FOREST LAKES  
PHASE 2

Major Amendment  
PUDSP -all sheets

PUDSP-18-001

DEVELOPMENT PLAN AND  
CONCEPTUAL SITE PLAN FOR PHASE 2

FOREST LAKES - PHASE 2			
PRELIMINARY GRADING & UTILITIES PLAN			
DESIGNED BY	MAL	SCALE	DATE 10/24/18
DRAWN BY	BB	(H) 1" = 60'	SHEET 15 OF 15
CHECKED BY		(V) 1" = N/A	JOB NO. 1175.21

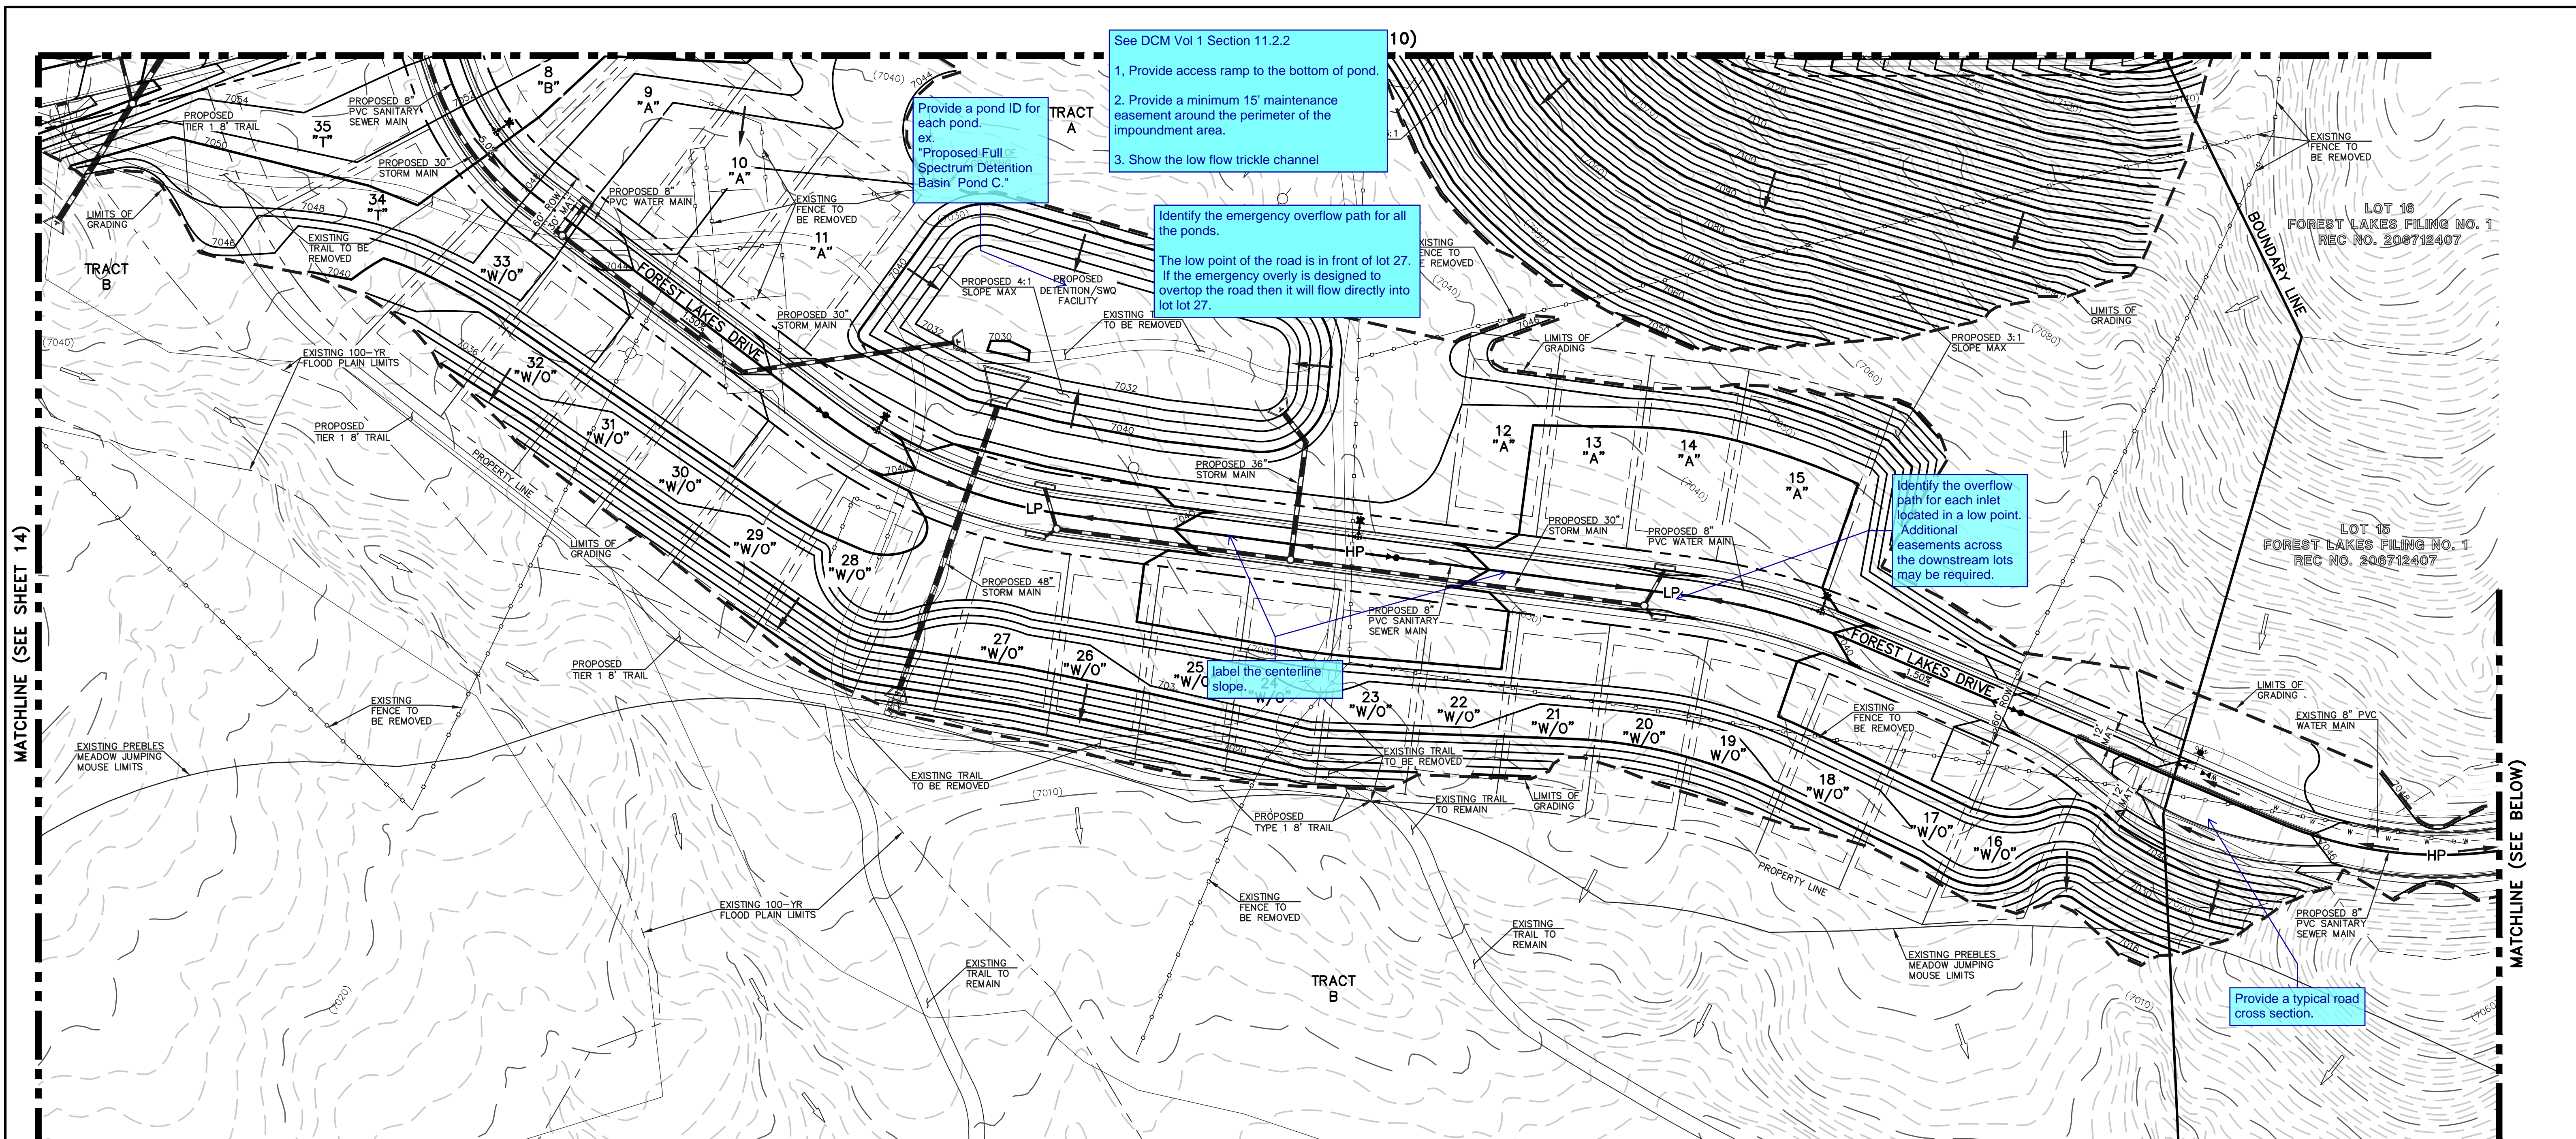
See DCM Vol 1 Section 11.2.2

1. Provide access ramp to the bottom of pond.
2. Provide a minimum 15' maintenance easement around the perimeter of the impoundment area.
3. Show the low flow trickle channel

Provide a pond ID for each pond.  
ex. "Proposed Full Spectrum Detention Basin Pond C."

Identify the emergency overflow path for all the ponds.  
The low point of the road is in front of lot 27. If the emergency overly is designed to overlap the road then it will flow directly into lot 27.

Identify the overflow path for each inlet located in a low point. Additional easements across the downstream lots may be required.

Label the centerline slope.

Provide a typical road cross section.
